Disability Access Report

Mixed Use Development
349 Barrenjoey Road,
NEWPORT NSW

For: Summit Build Pty Ltd
Ref: LP_20168

Figure 2 | Overall Site Plan

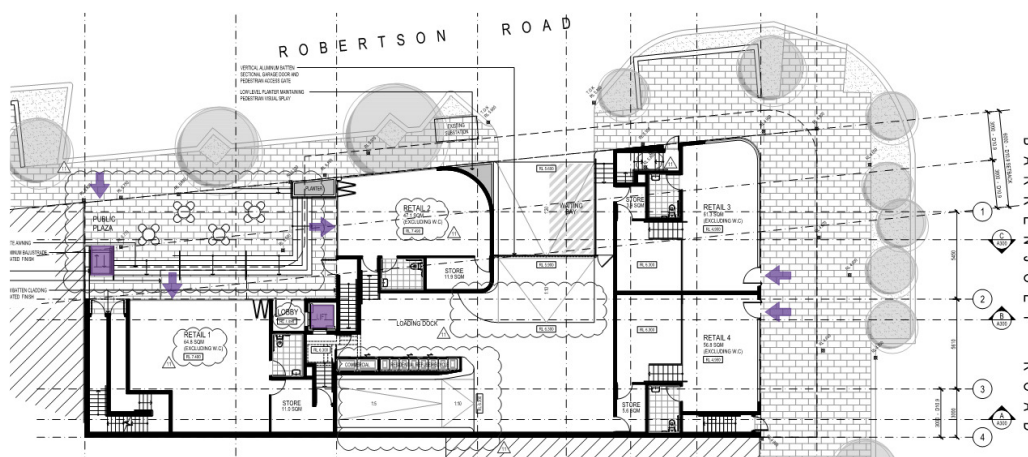
Level access is available from the street footpaths along Barrenjoey Road and Robertson Road to Retail Tenancies 3 & 4. A platform lift provides access between the public plaza and the entrance to Retail 1, Retail 2 and the Residential Lobby.

Lift access is provided from the basement carparking areas to the retail and residential entrances.

Carparking is provided at the basement level of the development. A total of nine (9) spaces are allocated to the retail component of the development with the remaining spaces allocated to residential units. The number of accessible spaces provides BCA compliance.

The turning bay forms the shared area for one of the accessible carparking spaces allocated to the retail tenancies. As such, there will be no bollard provided in this location. Given that the basement is a low-traffic area we consider this approach reasonable.

- a. Accessible carparking to be a minimum of 2400mm wide with a shared area to one side of the space 2400mm wide. Circulation space can be shared between adjacent accessible carparks.
- b. Provide a bollard to the shared circulation space as illustrated in AS2890.6, Figure 2.2.
- c. The maximum allowable crossfall of accessible carparking area to be, 1:33 (for outdoor spaces). This crossfall applies both parallel and perpendicular to the angle of parking.
- d. For covered carparking, the clear height of the accessible carparking space to be 2500mm as illustrated in AS2890.6, Figure 2.7.
- e. Designated accessible carparking is to be identified using the International Symbol for Access (ISA) –ground and vertical signage is required. Signage is to comply with AS1428.1.
